SUBJECT: Request to close a portion of Monterey Road Between northwest property line of CLT 068OA054 and the southern right-of-way line of Peppercorn Lane (to be closed MPC File # 9-C-12-SC) MPC File # 9-A-12-SC / City Block 40130

**Re: Right-of-Way Closure Request 9-A-12-SC
Block No. 40130
CLT No. 68
Parcel No. 14.02**

Closure of Monterey Rd File No. 9-A-12-SC Electric

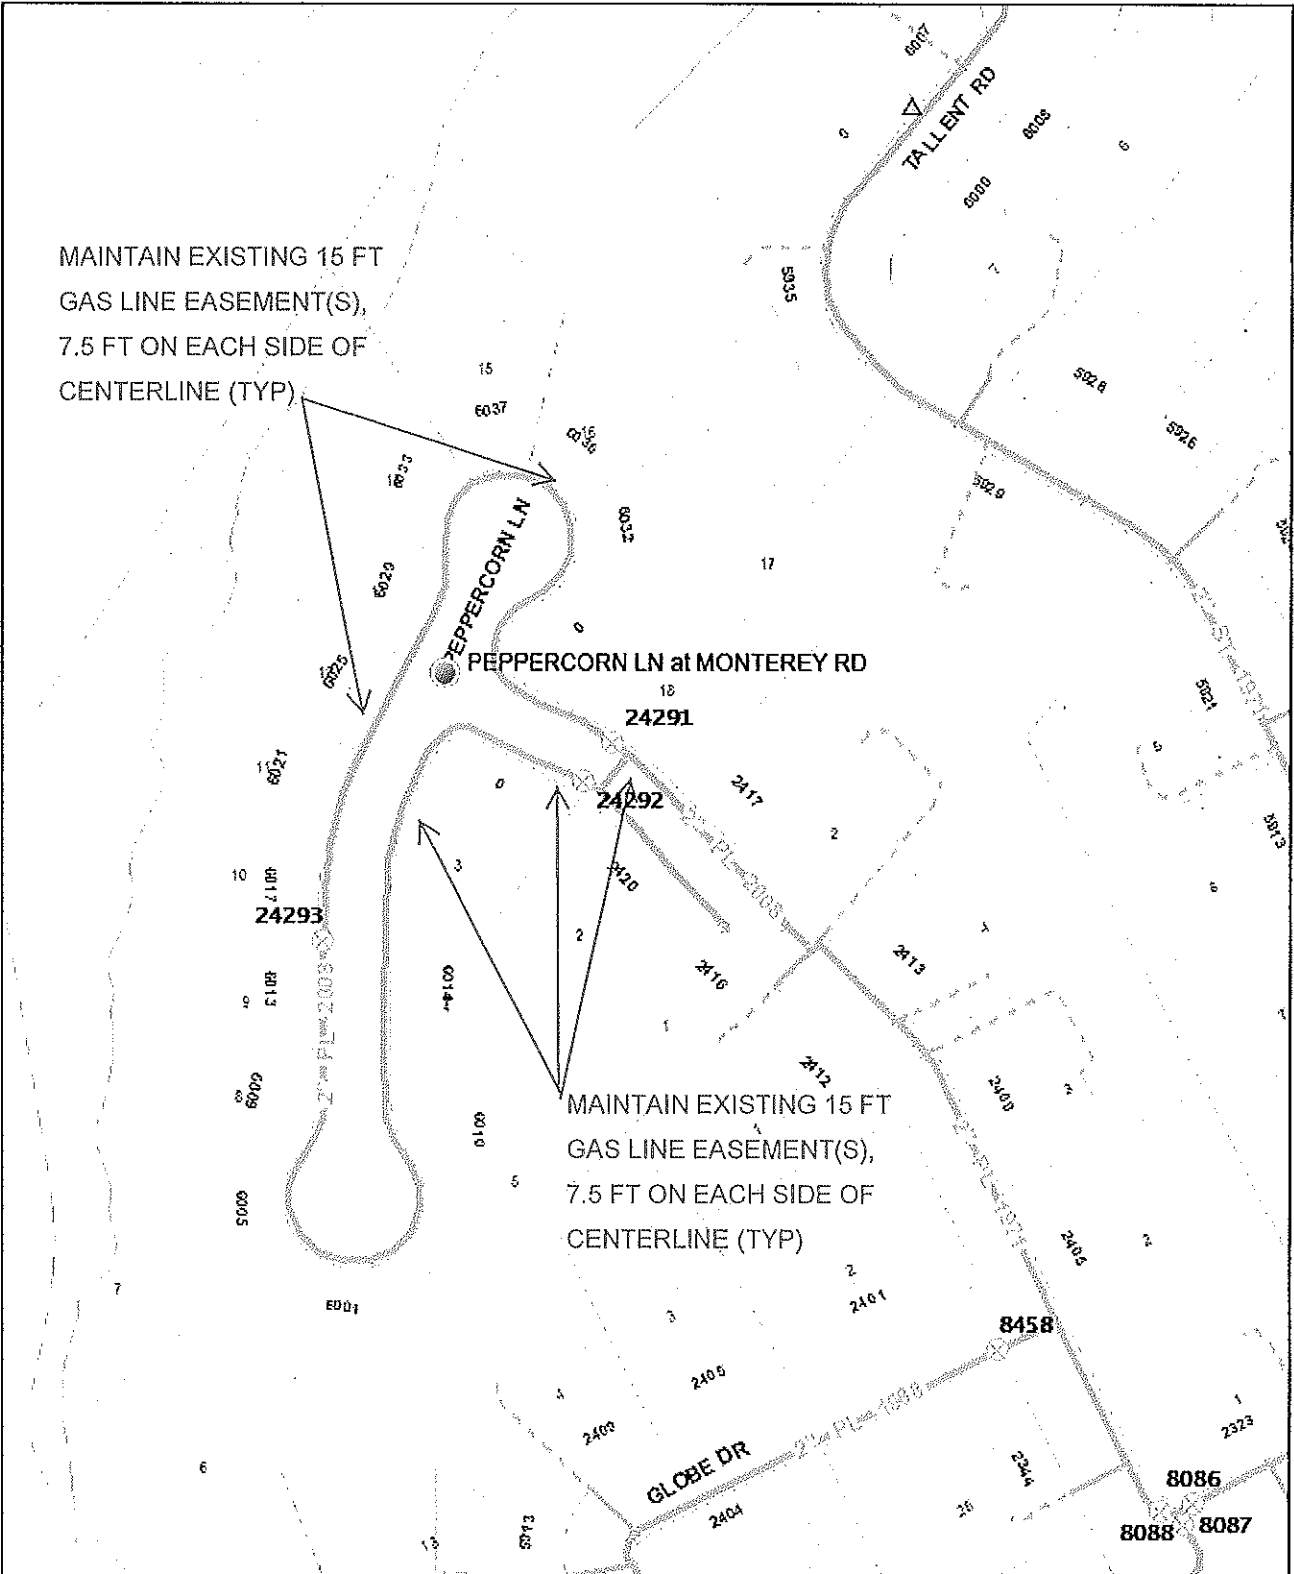
Electric – 10 feet on each side of the centerline of the electric line, 20 feet total width
Gas – 7.5 feet on each side of the centerline of the gas line, 15 feet total width
Sewer – 7.5 feet on each side of the centerline of the wastewater line, 15 feet total width
Water – 7.5 feet on each side of the centerline of the water line, 15 feet total width

Closure of Monterey Rd File No. 9-A-12-SC Gas

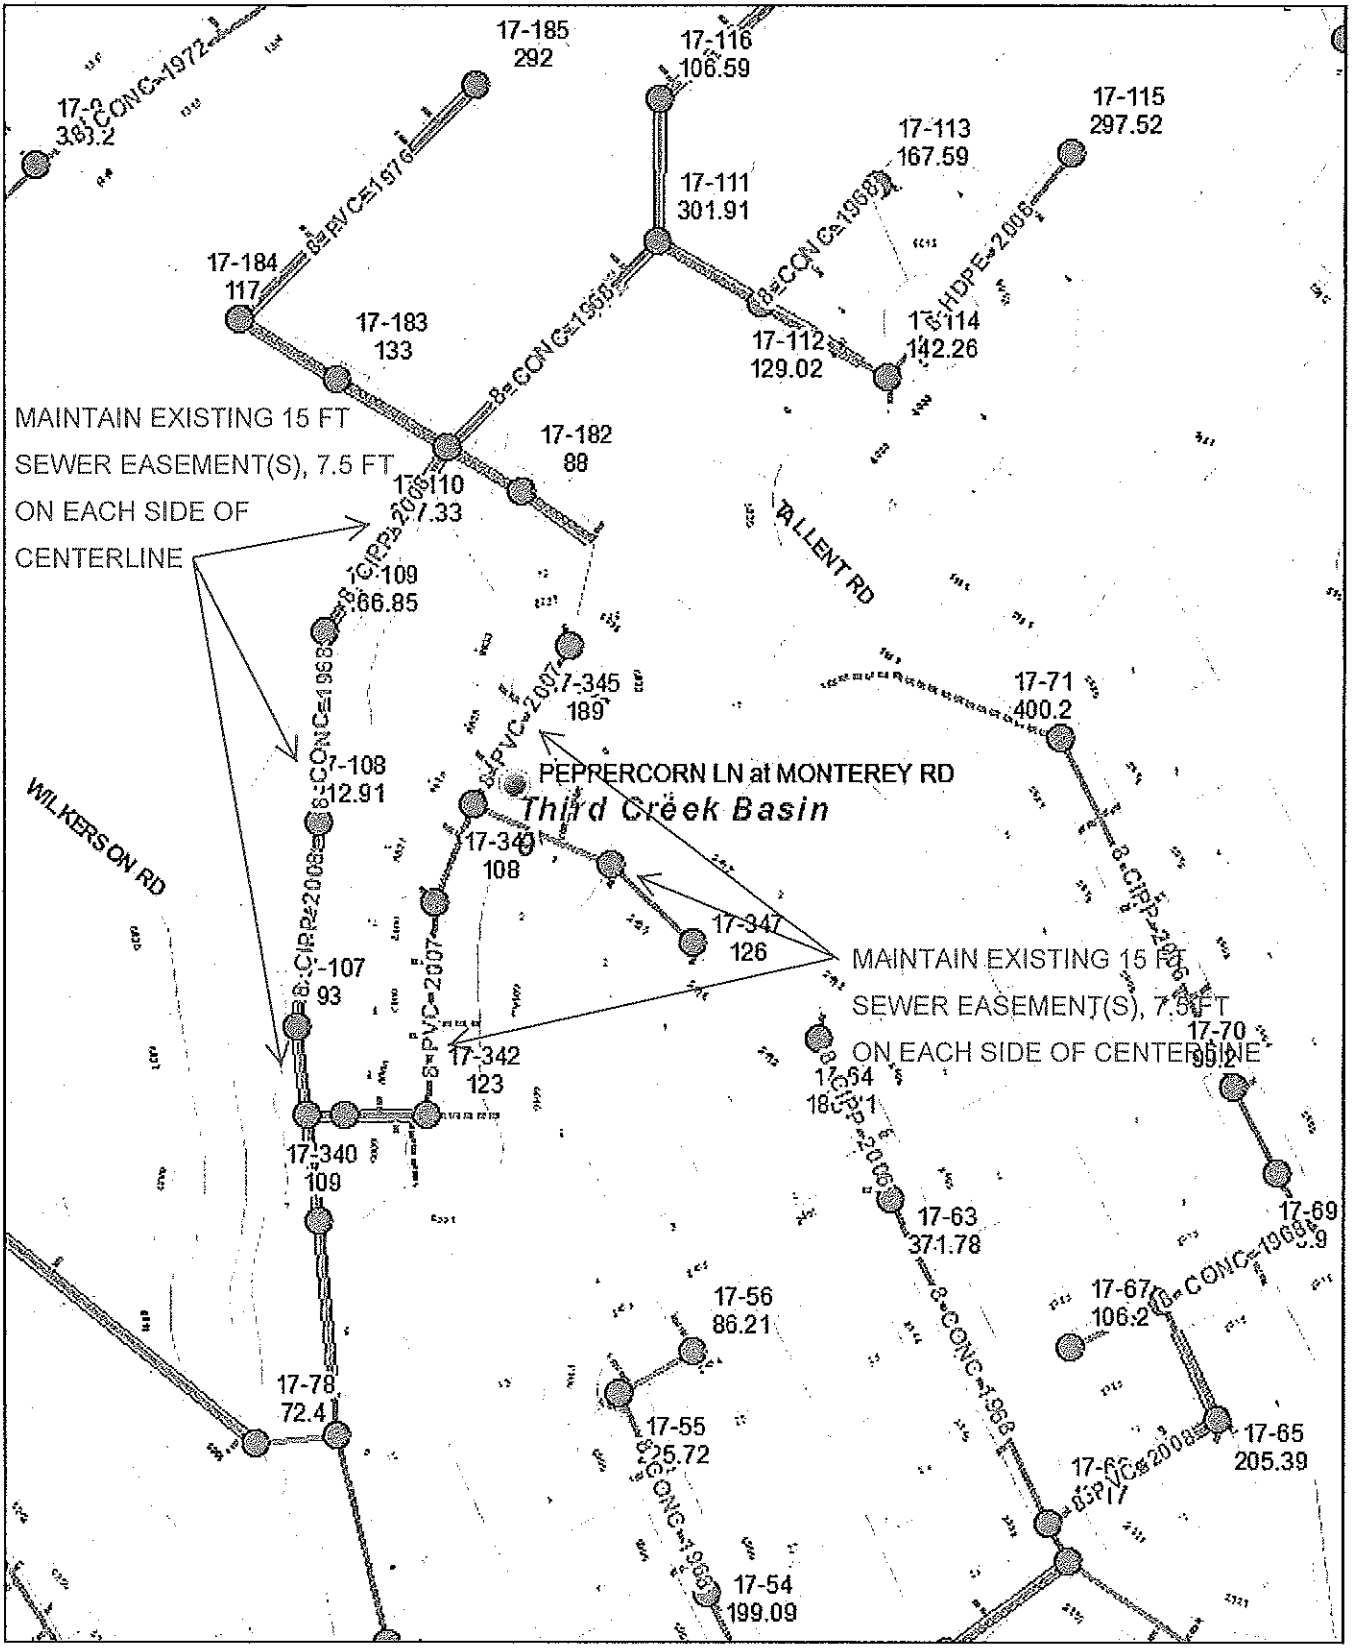
MAINTAIN EXISTING 15 FT
GAS LINE EASEMENT(S),
7.5 FT ON EACH SIDE OF
CENTERLINE (TYP)

MAINTAIN EXISTING 15 FT
GAS LINE EASEMENT(S),
7.5 FT ON EACH SIDE OF
CENTERLINE (TYP)
